Access Compliance Report

(Curb Ramps)

Intersection ID: 44303	Main Street: PAULINE_LN	Cross Street: THOMPSON_RD	Location: NE
ADA ID: 8D79E4BF20D2	Ramp Type: PerpDiag	Initial Pass/Fail: Pass	Overall Compliance: No
Severity Score: 5			
Codes/Mitigation Info/Possible Solution		Field Measurements/Component Compliance

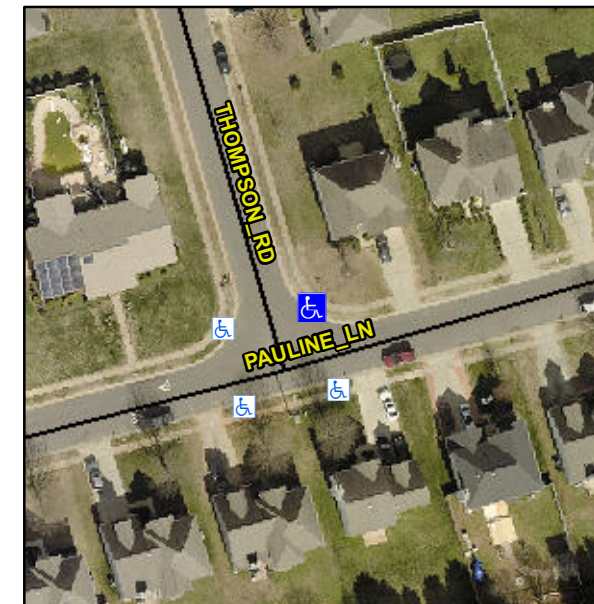
R304.2.1, R305.2, R304.5.4

Compliance	Description	Data	Compliance	Description	Data
N/A	Ramp Length (in)	48.5	Yes	Ramp Slope (%)	6.0
Yes	Ramp Width (in)	48.0	Yes	Ramp XSlope (%)	1.7
N/A	Flare Type LT	Sloped	N/A	Flare Type RT	N/A
N/A	Flare Slope LT (%)	4.3	Yes	Flare Slope RT (%)	5.1
N/A	Flare Traversable LT?	Yes	N/A	Flare Traversable RT?	Yes
No	Landing Length (in)	45.0	Yes	DWS Provided?	Yes
Yes	Landing Width (in)	48.0	Yes	DWS Contrast?	Yes
Yes	Landing Slope (%)	1.7	Yes	DWS Length (in)	24.0
Yes	Landing X Slope (%)	0.3	Yes	DWS Full Width?	Yes
N/A	Landing Curb? (Y/N)	No	No	DWS Offset (in)	4.0
N/A	Shared Landing?	No			
Yes	Gutter Ponding?	No	No	Gutter Slope (%)	8.5
Yes	Gutter Lip Ht (in)	0.0	Yes	Gutter X Slope (%)	0.8
N/A	Painted X Walk1?	No	N/A	Painted X Walk2?	No
	X Walk 1 Direction	To W		X Walk 2 Direction	To S
N/A	X Walk 1 Width (in)	N/A	N/A	X Walk 2 Width (in)	N/A
	X Walk 1 Slope (%)	0.4		X Walk 2 Slope (%)	0.5
	X Walk 1 X Slope (%)	0.2		X Walk 2 X Slope (%)	1.0

N/A	Ramp inside XWalk1?	N/A	N/A	Ramp inside XWalk2?	N/A
	Road Slope (%)	0.5	N/A	Clear Space?	Yes
	Road X Slope (%)	0.7	N/A	Clear Space to XWalk (in)	N/A
Yes	Any Obstructions?	No	Yes	Storm Grate/Utility Hazard?	No
	Obstruction Type			Storm Grate/Utility Type	
		N/A			N/A
			Yes	Surface Condition? (G/P)	Good

Remove & Replace Curb Ramp With Two New Directional Ramps or Equivalent. Remove & Replace Gutter.
